#### ADDENDUM: 1

### TENDER NR 8/3/57 – 2021 (MN 261 – 2021) CONSTRUCTION OF THE NORTHERN BOUNDARY WALL, PIKETBERG

**PROPOSED NEW BOUNDARY WALL ON ERF 3325, PATRIBERG**

PIER CONSTRUCTION DETAIL

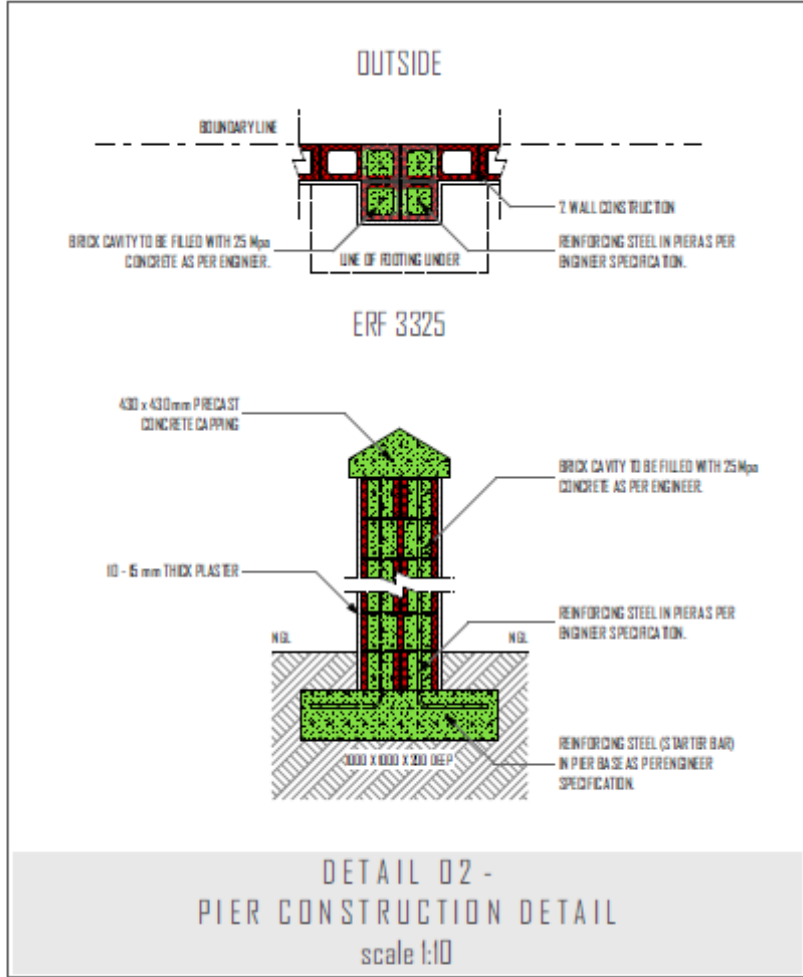
#### 1. BLOCK WORK

Blocks to be used as follow:

Piers: 190 x 190 x 390mm

In Between Walls: 190 x 140 x 390mm
